PROJECT NAME & NO.: 50/200

Addendum One

A. Bidder's Questions (Q) and Government's Responses (A).

SEPTIC TANK
 1500 GALLON

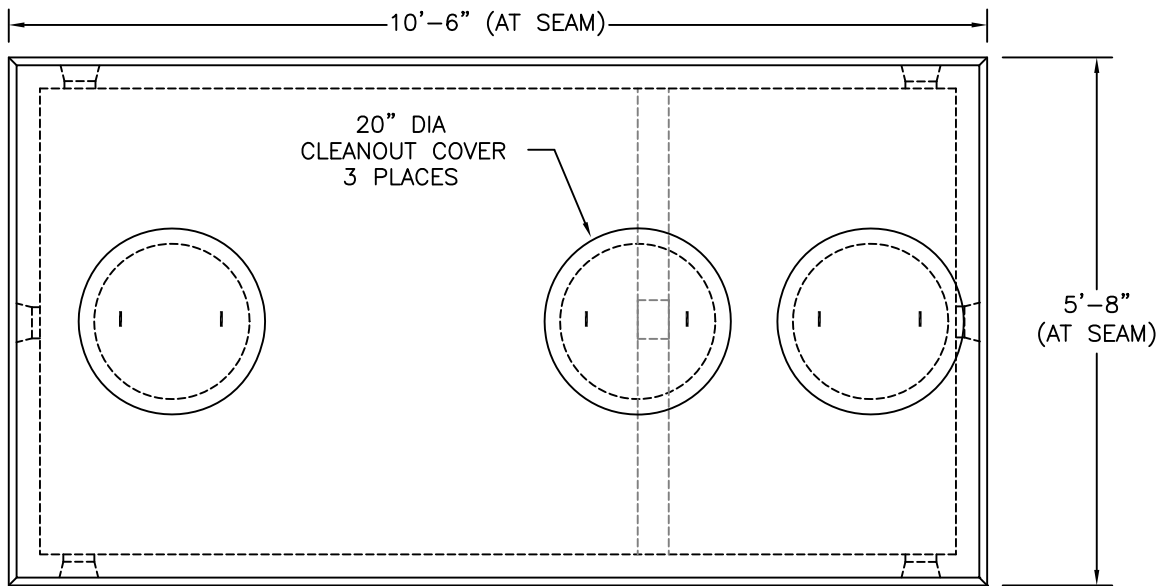
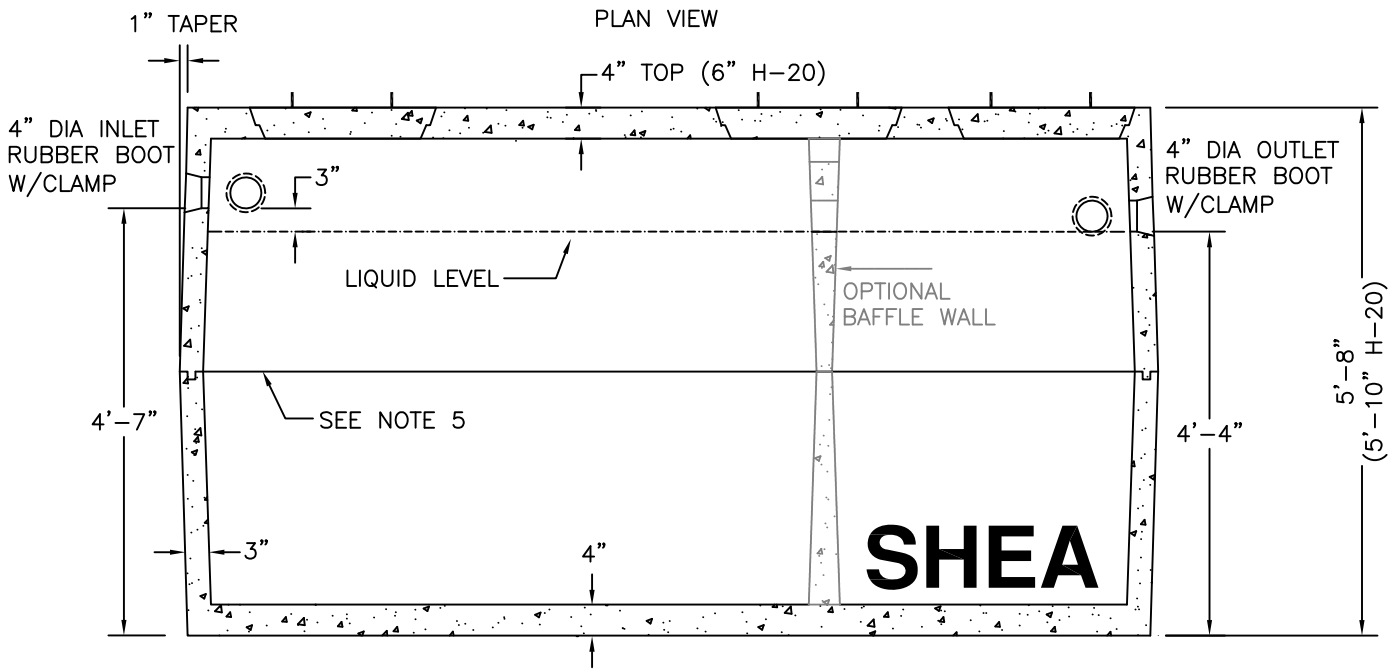
Q1. What is the specification for the 1500 gallon catch basin?

A1. The catch basin is to be of pre-cast concrete construction and the size of the basin shall be similar to the attached sketch. The details are offered as an example. Brand names are used to indicate general performance and quality levels. Unless otherwise noted, it is understood that other brands or models will be accepted on an "or equal" basis. A brand name has been used for the purpose of designating the standard of quality, performance, and characteristics desired and is not intended to restrict competition
